SERVICE BULLETIN

NO. SB-1

Model: A2

Subject: C-90-16F Continental Engine Breather Fitting

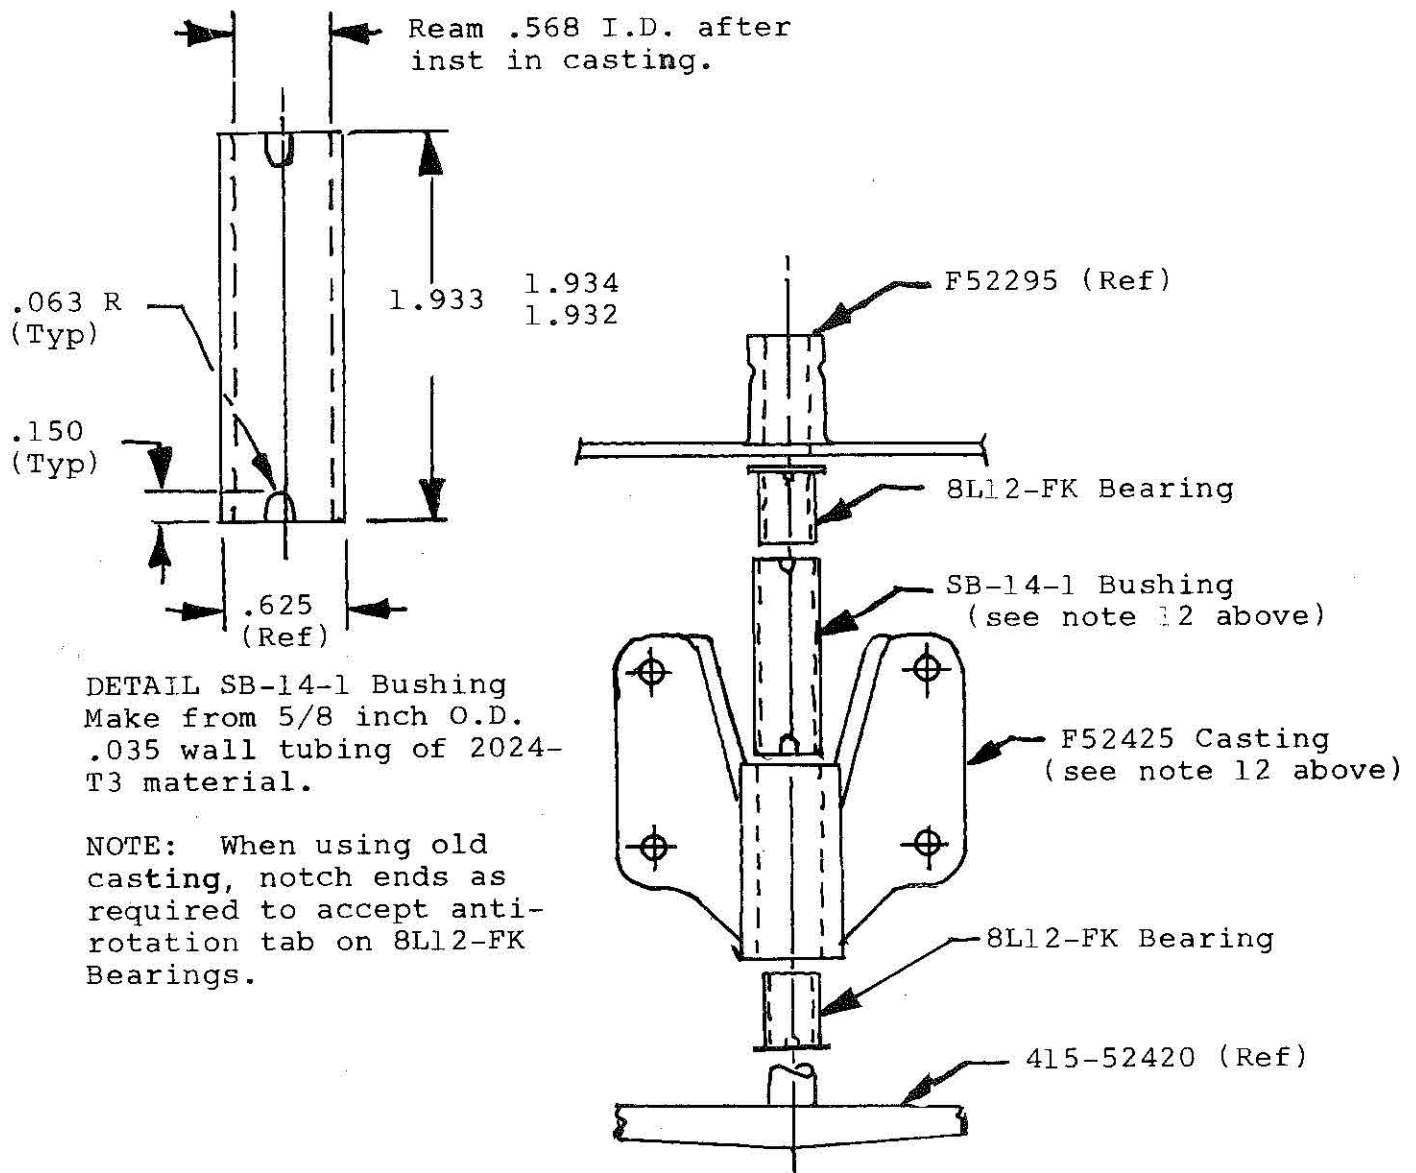
The purpose of this bulletin is to eliminate the possibilities of a rudder bellcrank seizure caused by the bakelite bushing that has expanded due to moisture within the bushing.

The above may be accomplished by replacing the bakelite bushing with the nylon bearings and by either installing the SB-14-1 bushing in the existing bellcrank casting or by replacement of the existing bellcrank casting with a new part which will eliminate the requirement for the SB-14-1 bushing.

1. Remove fairing at stabilizer leading edge to tail cone.
2. As required, loosen the trim tab conduit at the leading edge of the elevator and where it enters the tail cone.
3. Remove the tip of the tail cone (stinger) from the tail cone assembly.
4. Disconnect the elevator push rod from the elevator bellcrank.
5. Lift the elevator up and remove the four bolts that attach the stabilizer to the tail cone.
6. Lift the stabilizer, rudder and elevator as a unit - a few inches above the tail cone.
7. Remove the rudder control cables from the bellcrank arms.
8. Position the stabilizer in a suitable manner for the modification work. See "CAUTION" note on page 2 of this Service Bulletin.
9. Disconnect the rudder push rods from the rudder bellcrank arms.
10. Remove the four bolts that attach the bellcrank bracket to the stabilizer rear spar. The bellcrank assembly can now be removed.

FIGURE 1

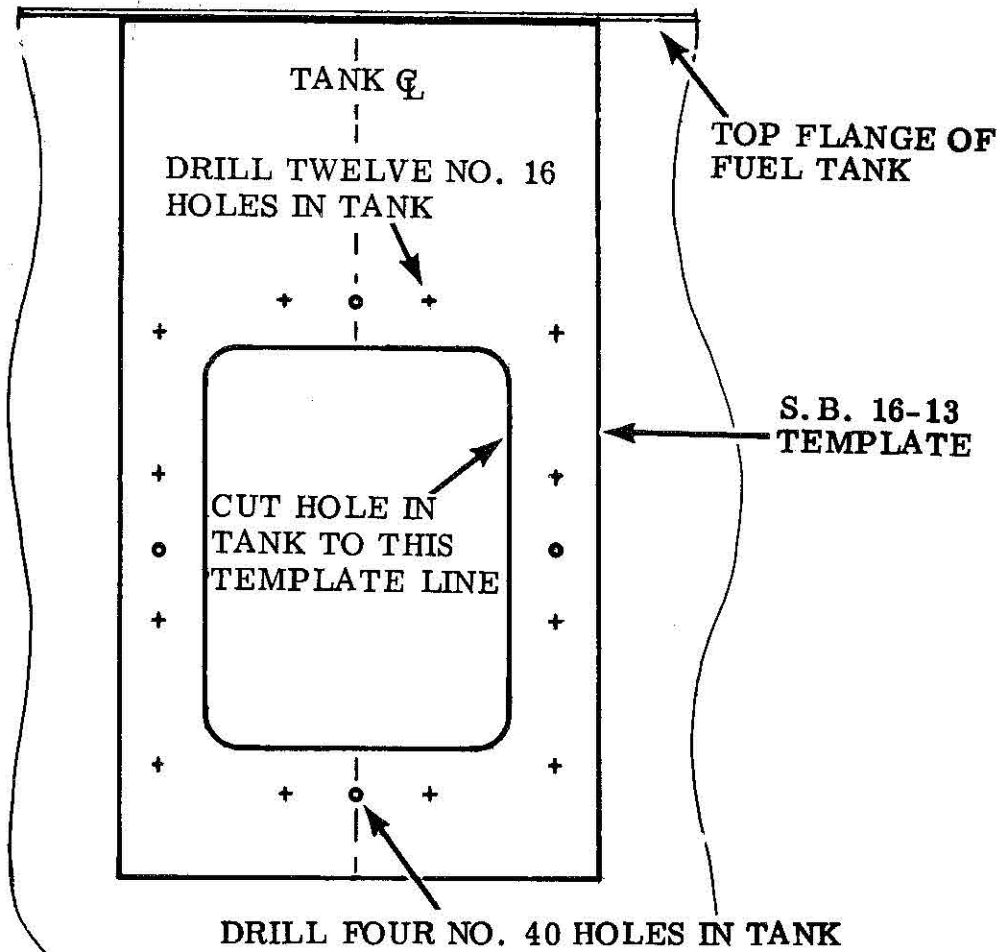
- a. Install AN913-2 plug in overflow return line fitting from which T-fitting has been removed.
- b. Locate template on center line of aft side of fuselage tank using top of tank as locating reference (See Figure 1).

FIGURE 2

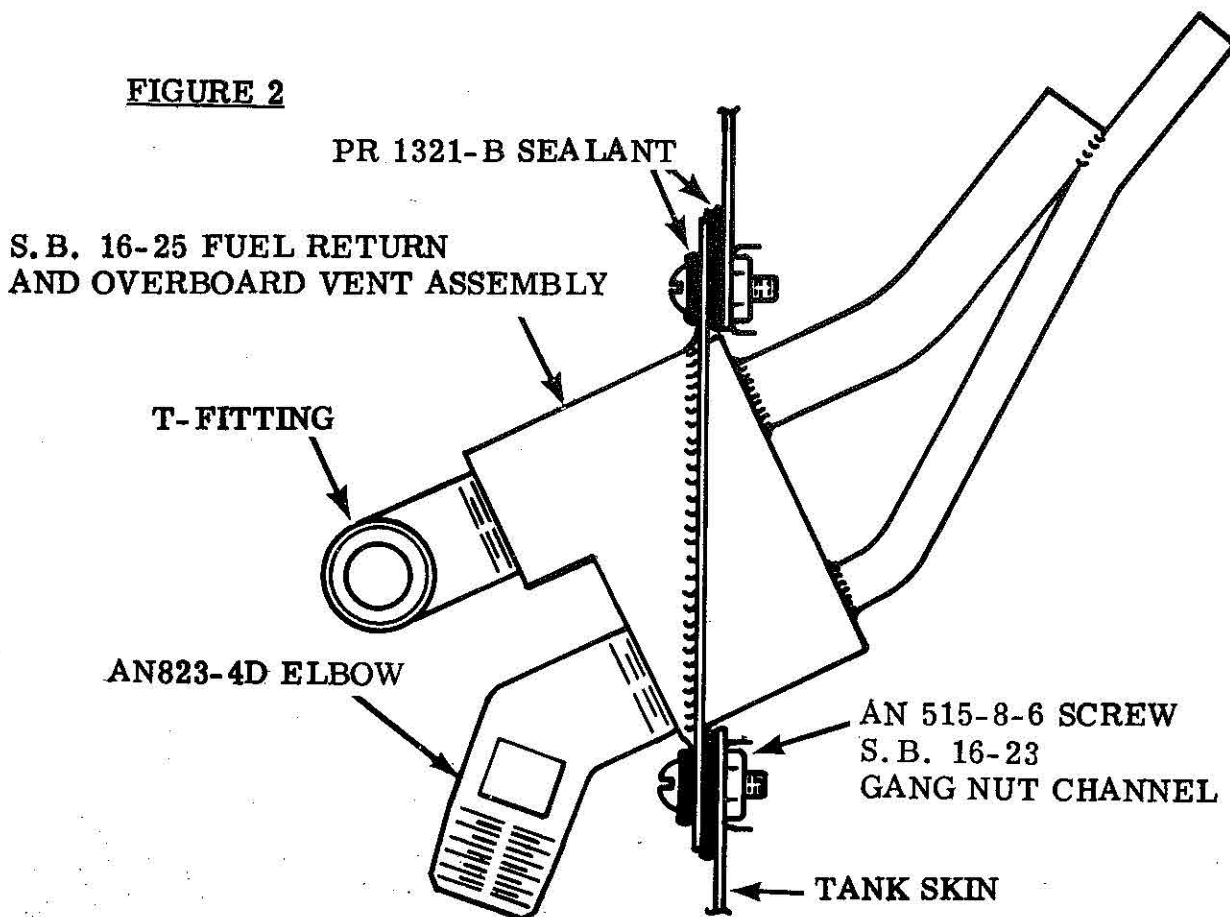
- i. Attach gang channels in place inside tank using four each AN507B-440R-4 screws and AN363-440 self locking nuts.
- j. Apply PR1321-B sealant to tank skin outer faying surfaces and to outer surface around attaching holes on S. B. 16-25 assembly (See Figure 2).

- k. Install S. B. 16-25 assembly with AN515-8-6 (12) screws through tank skin and gang channels (See Figure 2) making sure that tubes point to inside top of tank. Tighten screws and allow sealant to cure about 24 hours under normal conditions.

FIGURE 3

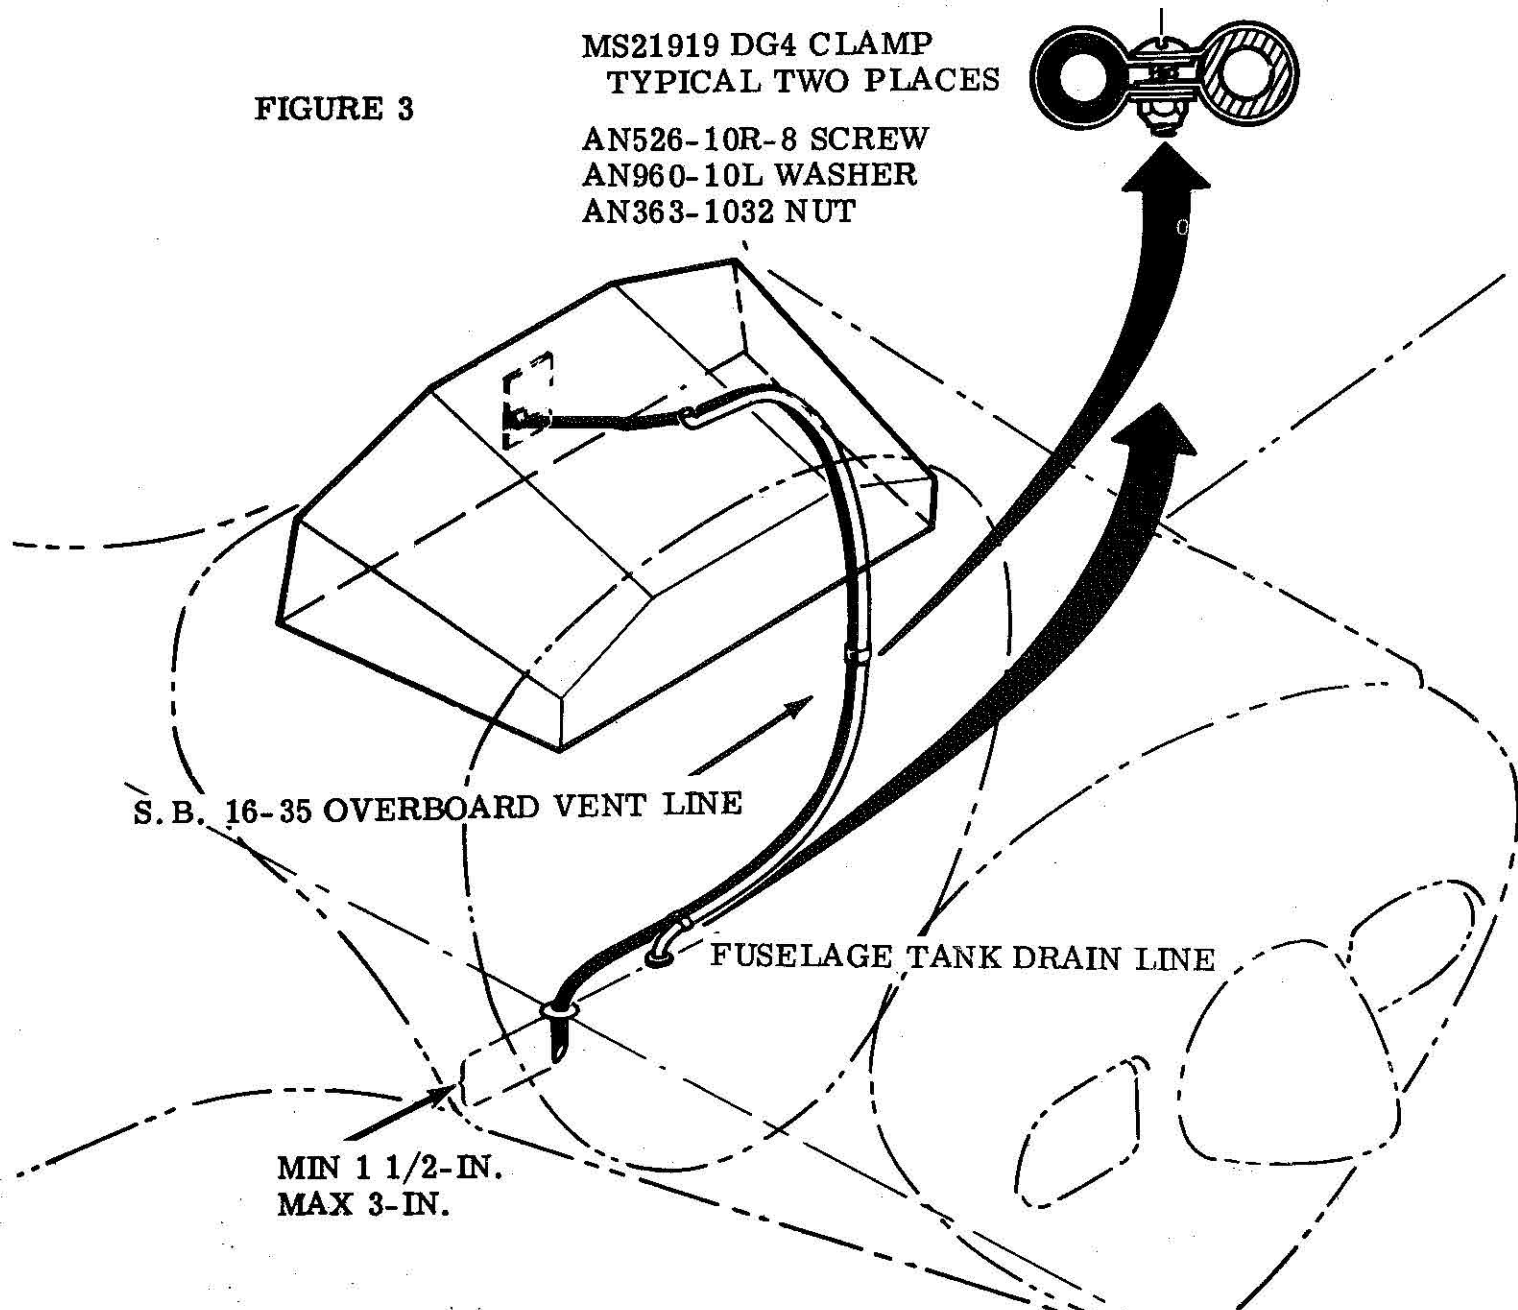
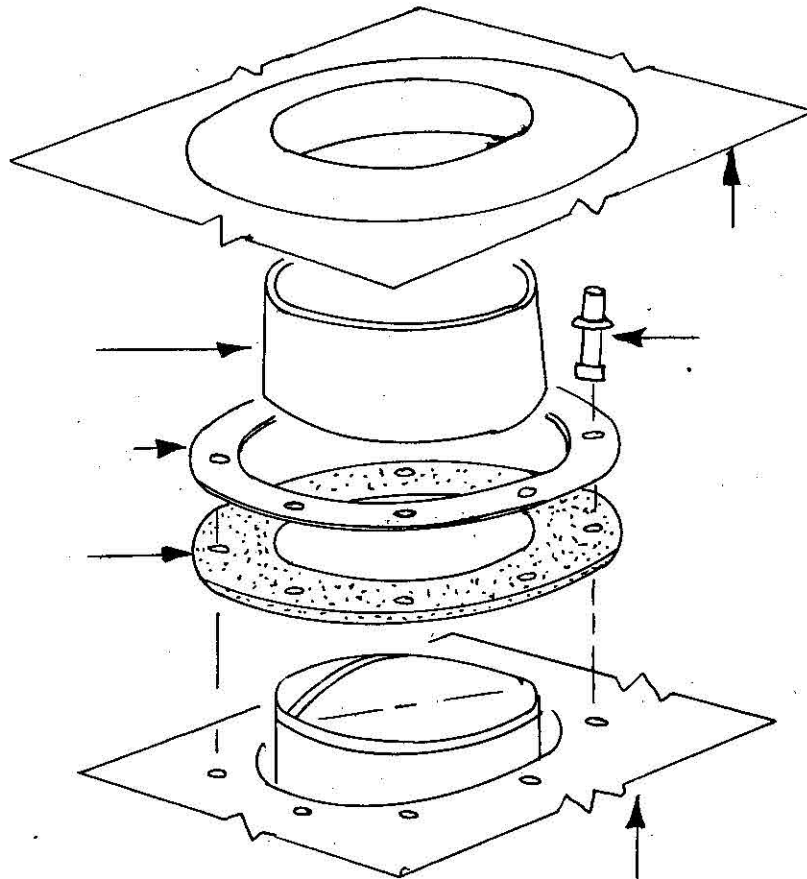
- s. Connect S. B. 16-35 overboard fuel vent line assembly to bottom fitting of S. B. 16-25 assembly. Route line next to fuselage tank drain line and through grommet in belly skin. Be sure beveled edge of overboard vent line faces forward and that drain lines protrude a minimum of 1-1/2 inches below belly skin.
- t. Secure overboard vent line to fuselage tank drain line by positioning two pair of MS21919 DG4 clamps, using AN526-10R-8 screw, AN960-10L washer, and AN363-1032 nut, as shown on Figure 3.
- u. Reinstall instrument panels, control wheels, and shafts in reverse sequence of removal.
- v. Reattach engine control retaining clamps to tank.
- w. Reinstall fuel lines on tank fittings and leak-check all connections after refueling tank.

FIGURE 5

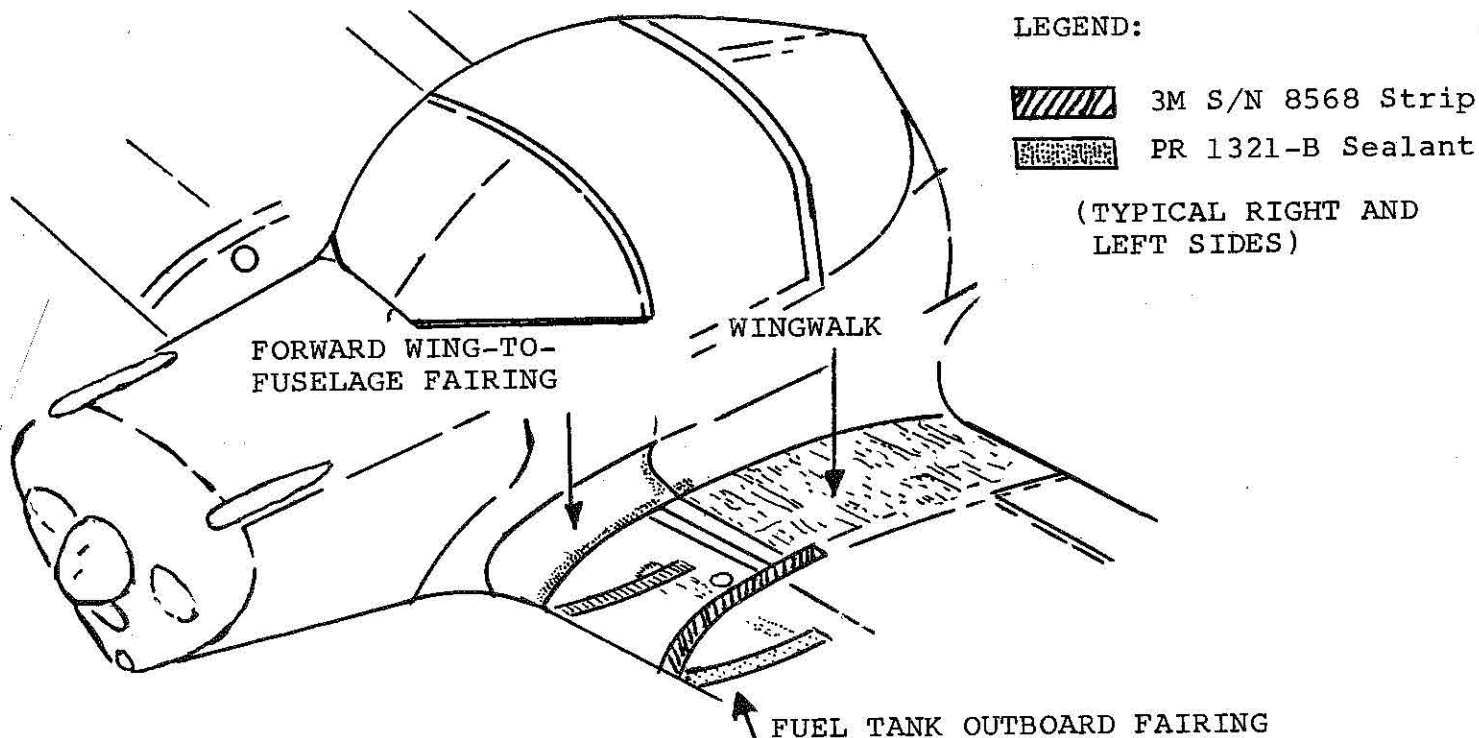
INSTRUCTION III Airframe Sealing (See Figure 5).

Step 2. Apply sealant as shown in preceding illustration.

- NOTES: Make certain there are no gaps that could make sealing difficult where fairings contact the wing. Apply sealant (approximately 1/16 inch thick layer) between fraying surfaces.
- Apply a coat of PR1321-B sealant (about .50 to .75 inch wide) to outboard edge of forward wing-to-fuselage fairing extending from wing leading edge back to four inches aft of the fairing rear edges on both top and bottom sections of the fairing.
 - Apply PR1321-B sealant to upper and lower aft edges of fuel tanks. Seal any gaps found in wing-walk skin joggle above spar.
 - Reinstall wing tanks and fuel lines.
 - Use strip calk (3M P/N 8568) to seal top and bottom inboard edges of wing fuel tank outboard fairings.

FIGURE 1
(VIEW LOOKING DOWN ON BOTTOM SIDE OF FUSELAGE TANK)
SCALE: NONE

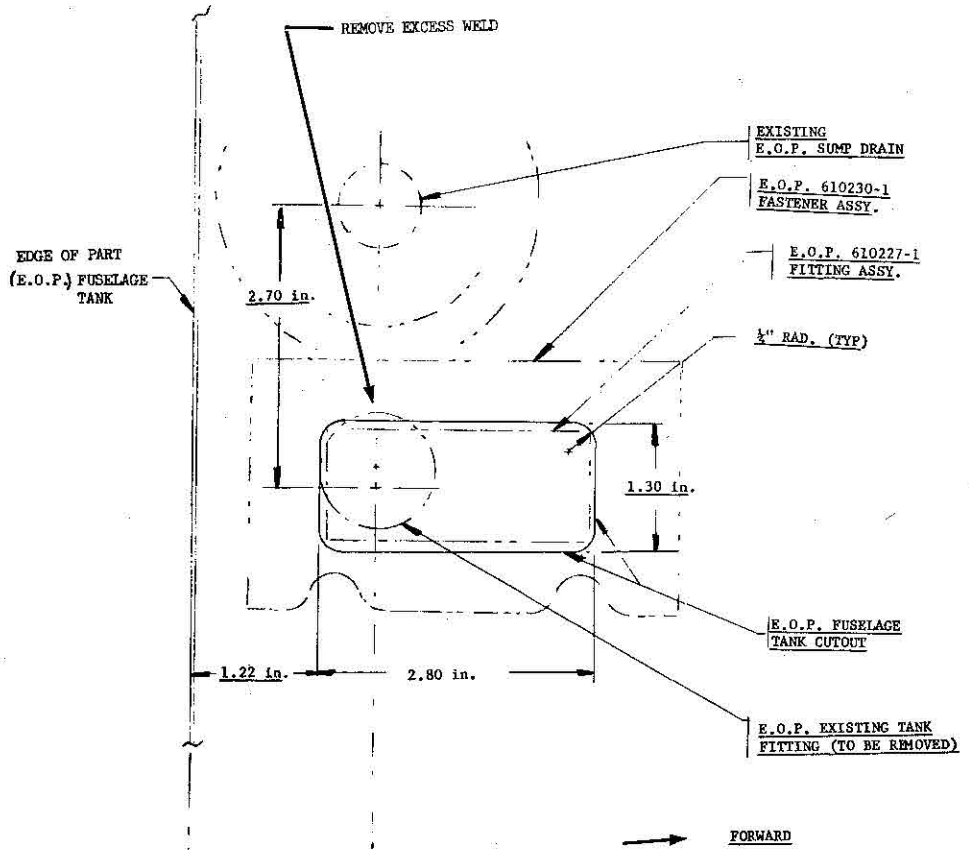
9. Remove all fittings from tank.
- b. Modification of fuel tank outlet fitting.
 1. Remove fitting by cutting 1.30 X 2.80 inch hole as shown on Figure 1.

FIGURE 2
(Bottom of Fuselage Tank-Section)
Scale: NONE

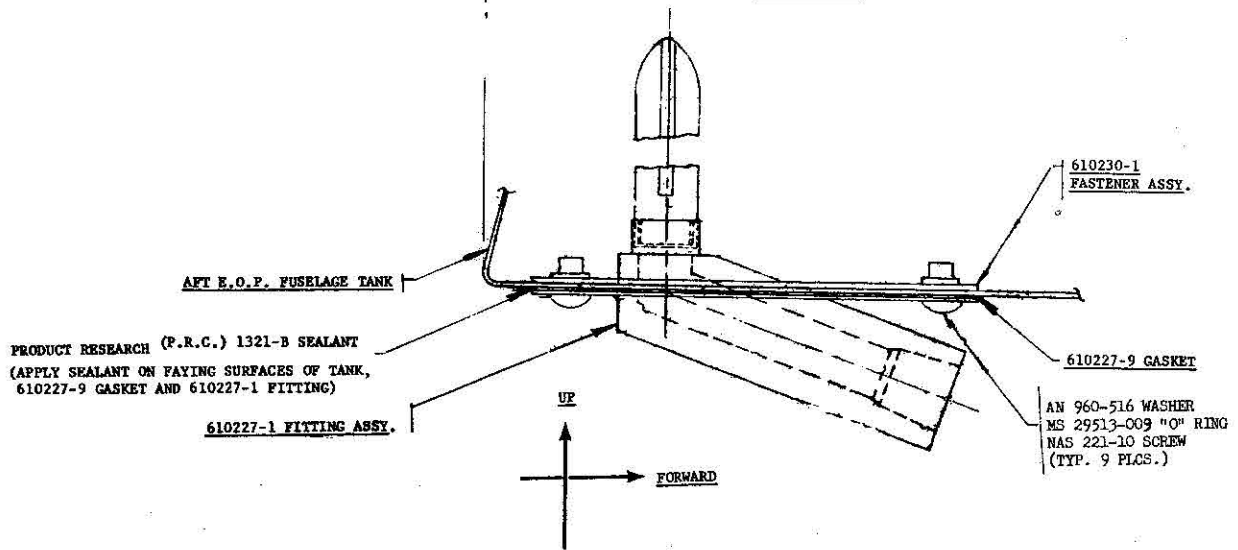
2. Remove excess weld of existing tank fitting and install 610230-1 nut plate assembly (See Figure 2) with two No. 3 flush rivets.
 3. Thoroughly clean tank, removing all burrs and metal shavings.

4. Position P/N 610227-1 fuel tank fitting assembly on 1.30 X 2.80 cutout as shown in Figure 2.
 5. Apply PRC 1321-B sealant, install P/N 610227-9 gasket, NAS 221-10 screw, AN960-516 washer, and MS 29513-009 O-ring as shown and noted in Figure 2.
